Access Compliance Report

Public Rights-of-Way

(Curb Ramps)

Intersection ID: 47663	Main Street: ELM_BEND_DR	Cross Street: COMISKEY_LN	Location: SW
ADA ID: 1CD0E470303E	Ramp Type: BlendTrans1	Initial Pass/Fail: Fail	Overall Compliance: No
		Severity Score: 12.5

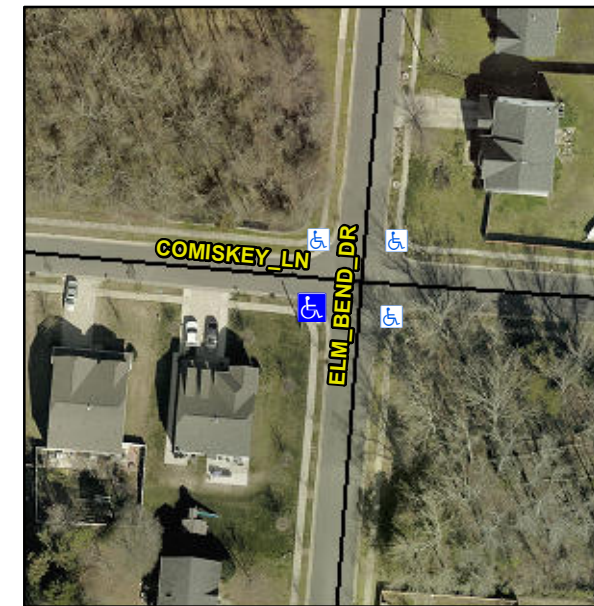
Not Found, R304.5.3

Compliance	Description	Data	Compliance	Description	Data
N/A	Ramp Length (in)	51.5	Yes	BlendTrans Slope (%)	1.9
Yes	Ramp Width (in)	48.0	No	BlendTrans XSlope (%)	5.2
N/A	Flare Type LT	N/A	N/A	Flare Type RT	N/A
N/A	Flare Slope LT (%)	N/A	N/A	Flare Slope RT (%)	N/A
N/A	Flare Traversable LT?	N/A	N/A	Flare Traversable RT?	N/A
N/A	Landing Length (in)	N/A	N/A	DWS Provided?	N/A
N/A	Landing Width (in)	N/A	N/A	DWS Contrast?	N/A
N/A	Landing Slope (%)	N/A	N/A	DWS Length (in)	N/A
N/A	Landing X Slope (%)	N/A	N/A	DWS Full Width?	N/A
N/A	Landing Curb? (Y/N)	N/A	N/A	DWS Offset (in)	N/A
N/A	Shared Landing?	N/A			
N/A	Gutter Ponding?	N/A	N/A	Gutter Slope (%)	N/A
N/A	Gutter Lip Ht (in)	N/A	N/A	Gutter X Slope (%)	N/A
N/A	Painted X Walk1?	No	N/A	Painted X Walk2?	No
	X Walk 1 Direction	To E		X Walk 2 Direction	To N
	X Walk 1 Width (in)	N/A		X Walk 2 Width (in)	N/A
	X Walk 1 Slope (%)	3.1		X Walk 2 Slope (%)	1.5
	X Walk 1 X Slope (%)	0.4		X Walk 2 X Slope (%)	3.8

N/A	Ramp inside XWalk1?	N/A	N/A	Ramp inside XWalk2?	N/A
	Road Slope (%)	2.3		Clear Space?	N/A
	Road X Slope (%)	0.1	N/A	Clear Space to XWalk (in)	N/A
N/A	Any Obstructions?	N/A	N/A	Storm Grate/Utility Hazard?	N/A
	Obstruction Type			Storm Grate/Utility Type	
		N/A			N/A
			Yes	Surface Condition? (G/P)	Good
			No	Curb Slope (%)	6.0

Remove & Replace Curb Ramp With Two New Directional Ramps or Equivalent.
